NOTICE OF PROJECT CHANGE

15 Necco Street

5 and 15 Necco Street, Boston MA 02210

**Re: Notice of Project Change
15 Necco Street
Boston, MA**

Figure 1.4
Previously Approved Project

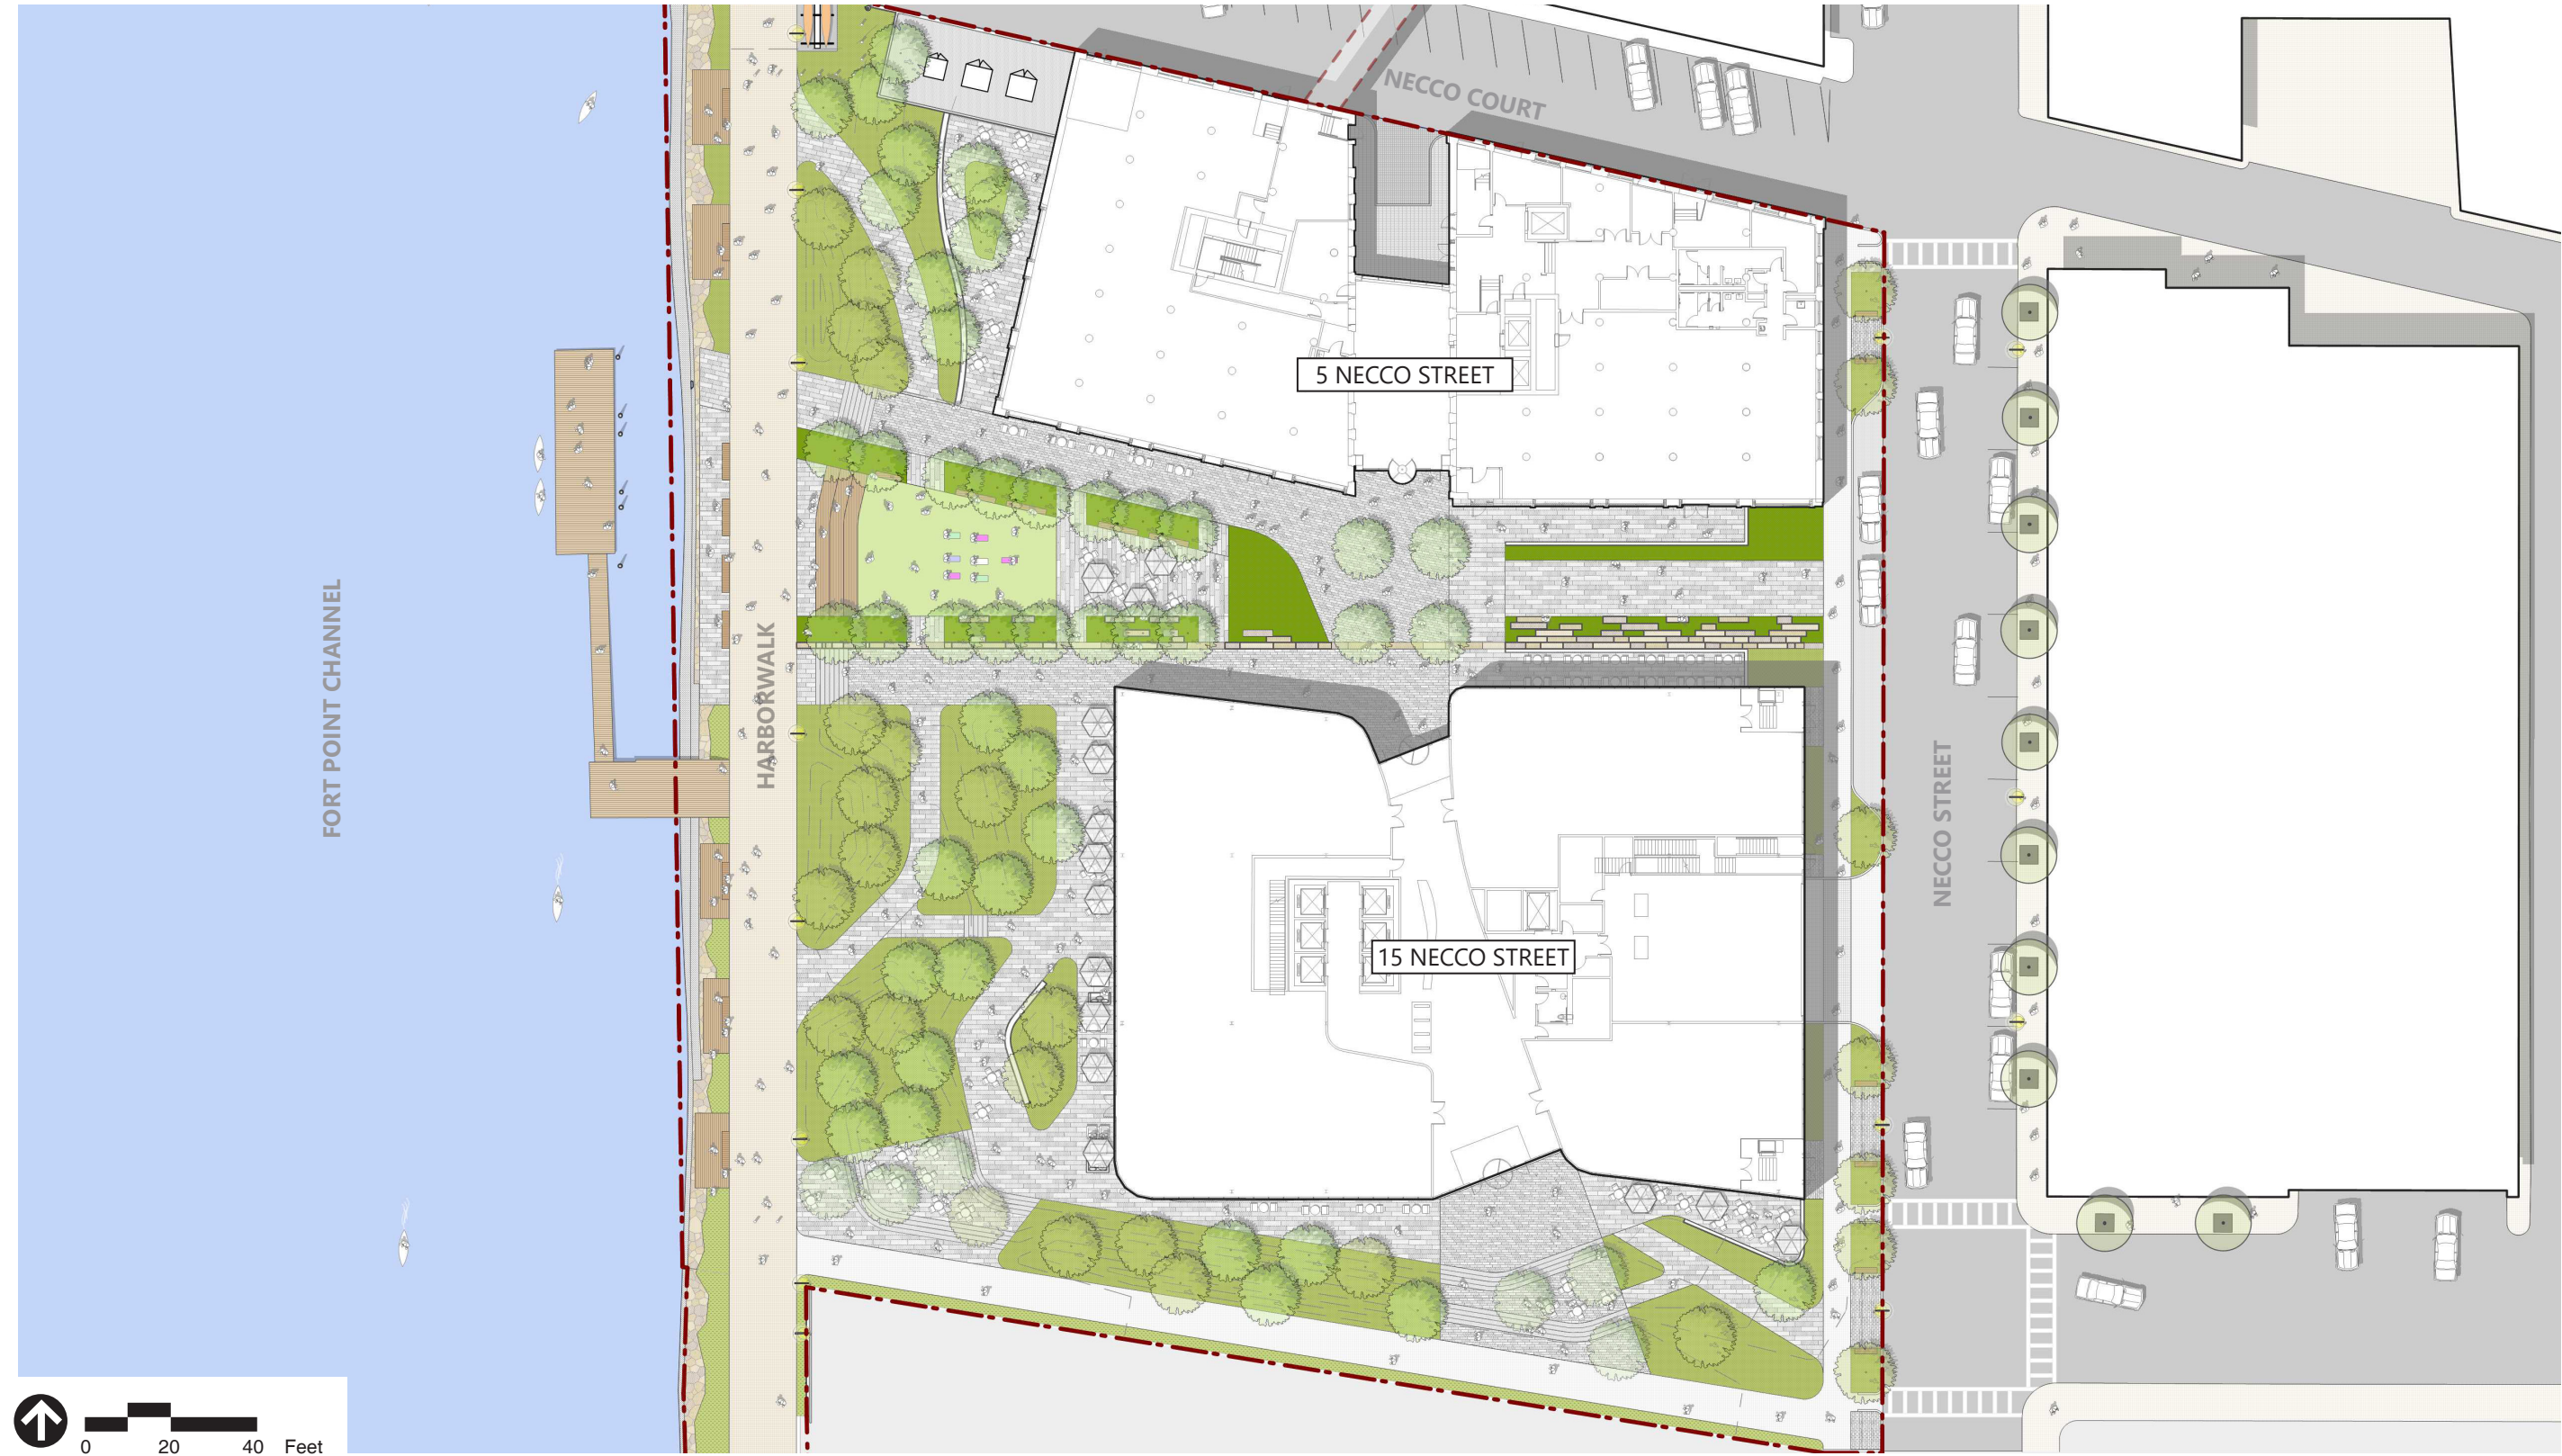
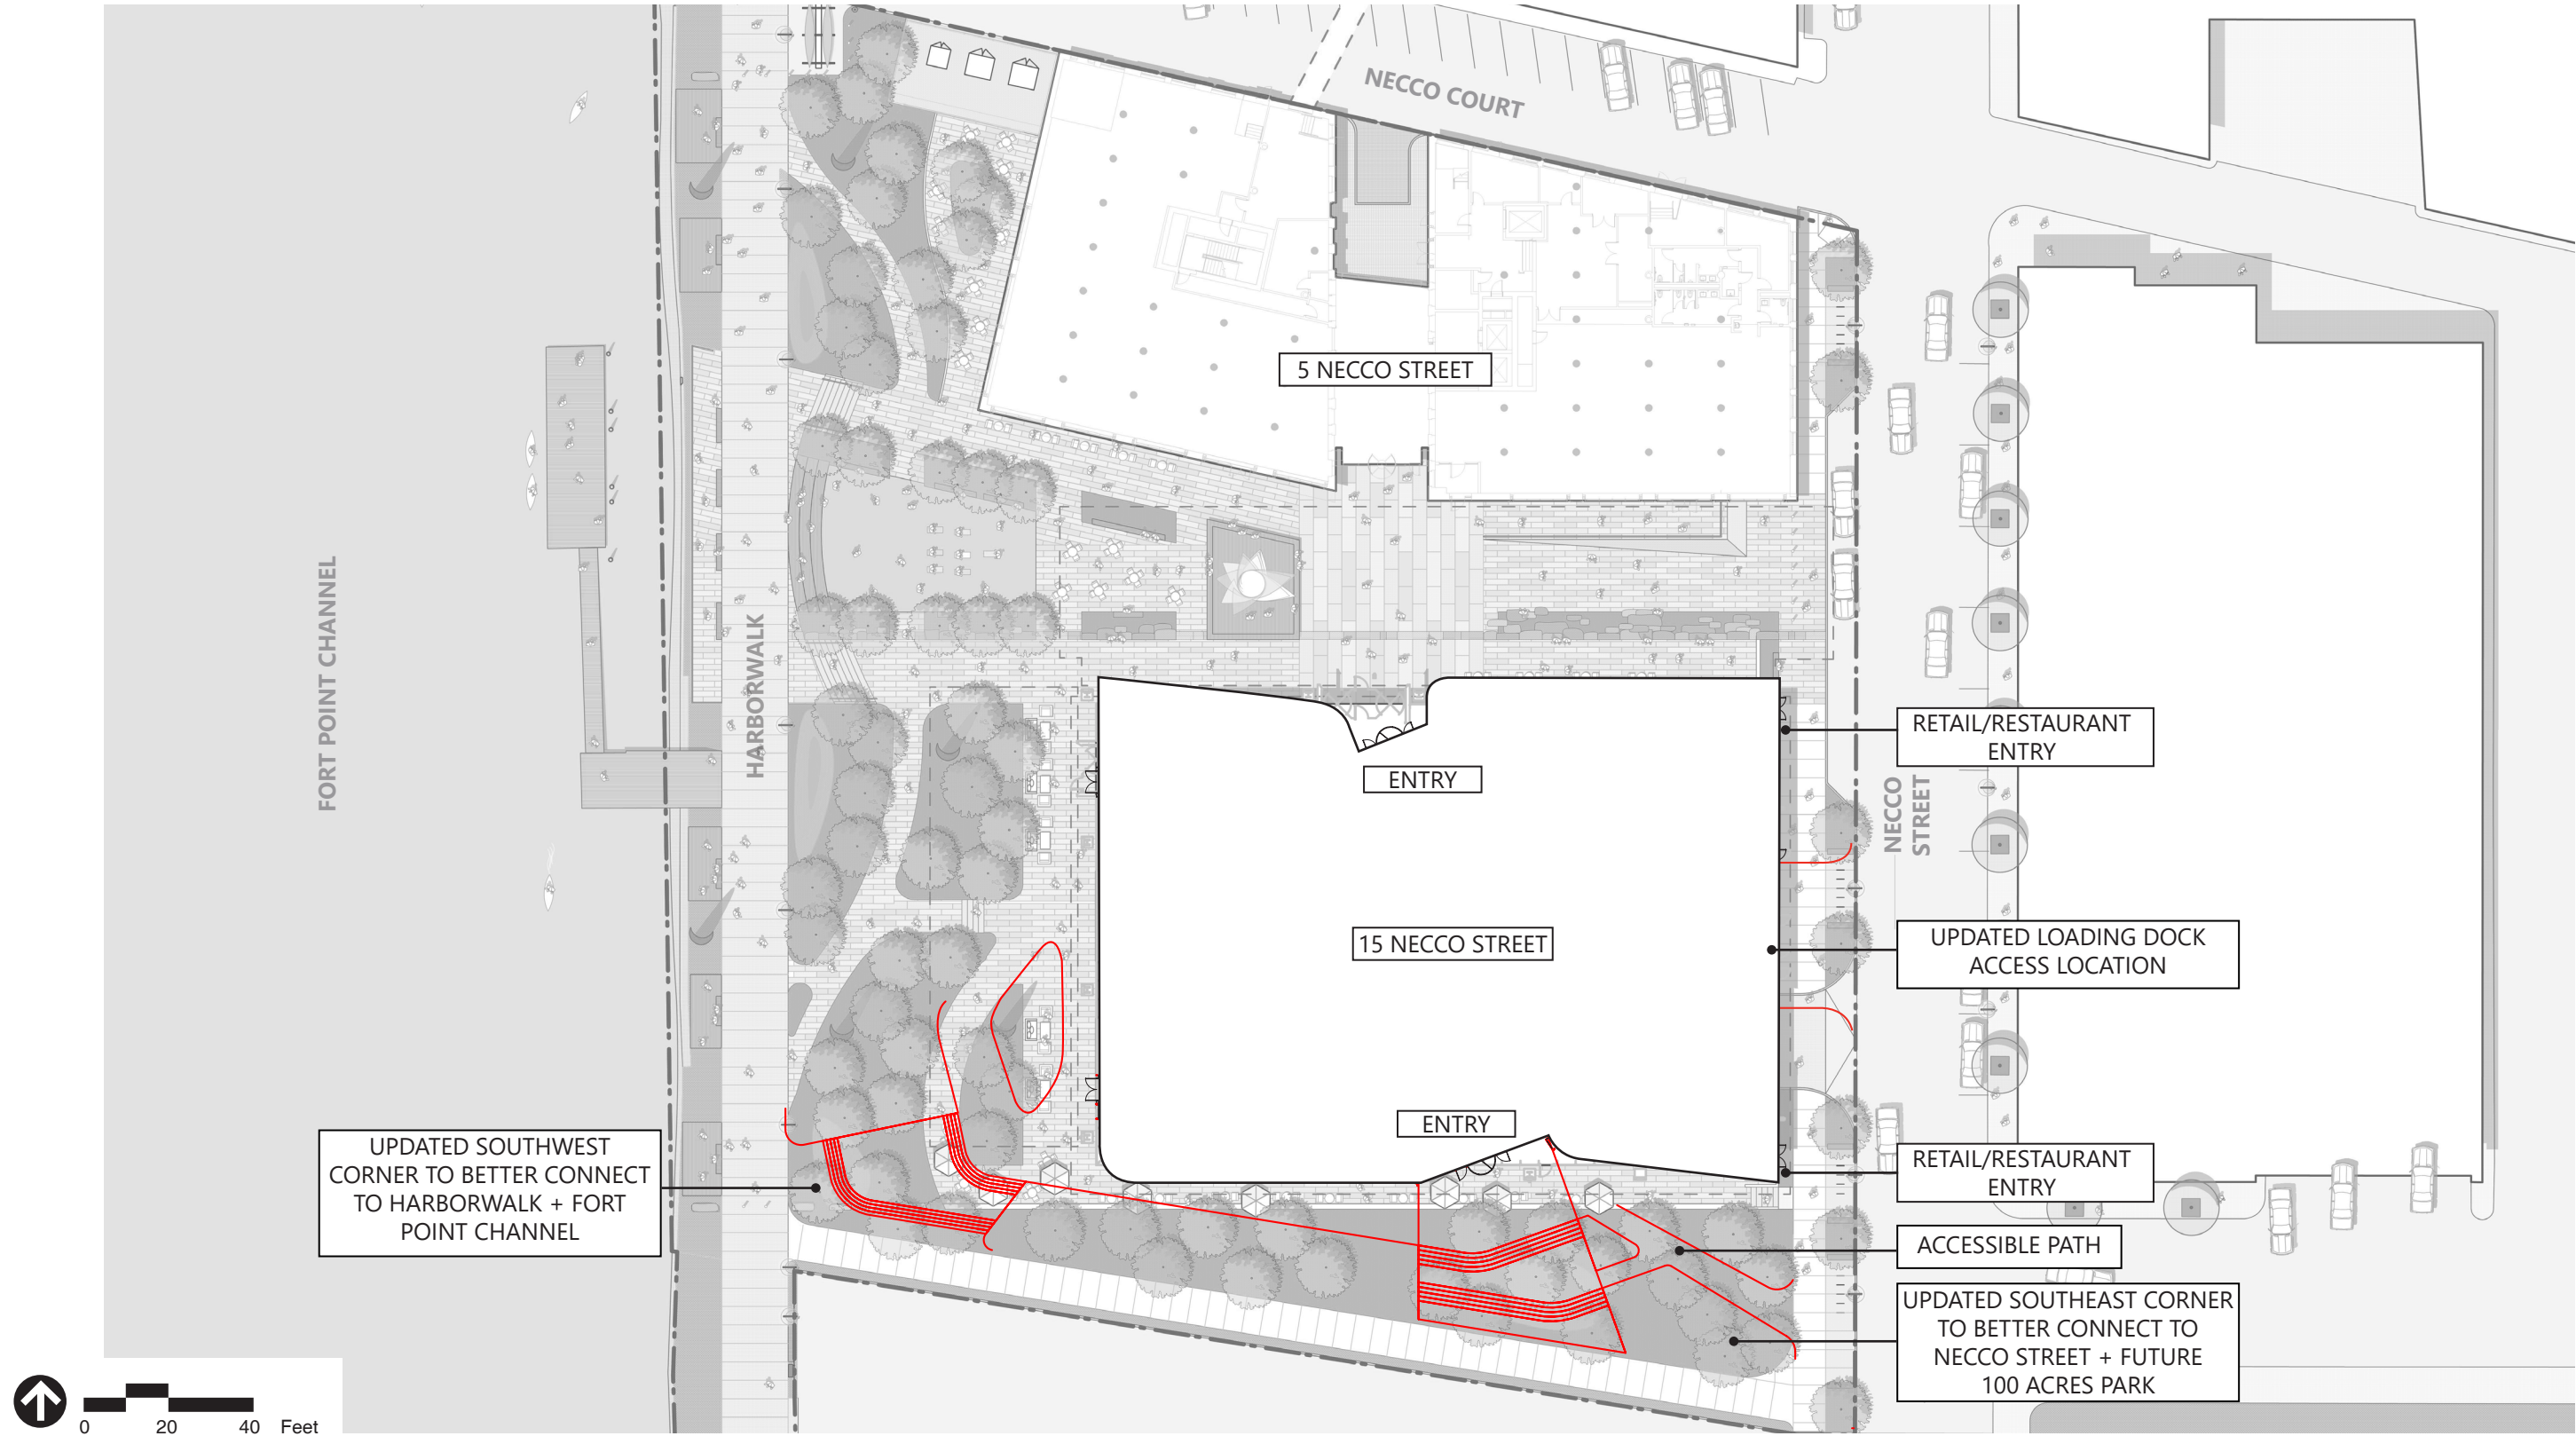
The following section summarizes the proposed modifications to the New Building component of the previously approved project. Figure 1.4 presents the previously approved project site plan. The previously approved project was contemplated to include GE occupancy in both 5 Necco Street and the new office building at 15 Necco Street; GE will now occupy office space only at 5 Necco Street. The Proponent proposes the construction of a new, 12-story, approximately 316,000-square foot ("SF") multi-tenant office/life sciences/research and development building with active ground floor uses, such as retail and restaurant spaces within the southern portion of the Project Site (15 Necco Street). Because of the Project Site's proximity to public transit and nearby public parking facilities, the New Building will not include any underground parking. (Please refer to Figure 1.5 for the proposed site plan for the Proposed Project.)

Figures 1.4 and 1.5 presents a side-by-side comparison of the previously approved project and Project ground floor plans. The new architectural design for the New Building responds to the anticipated multi-tenanted office and life science, research and development, retail and restaurant uses, and includes indoor spaces that will welcome the public, as well as a roof terrace amenity for building tenants. The New Building will have two main entryways on its northern and southern facades, in order to create a new, accessible and weather protected north-south pedestrian corridor through the building to facilitate pedestrian connectivity in the area, and providing new, accessible connections to the future open space area to the south of the Project Site (Figure 1.6). The new building entrance on Necco Street
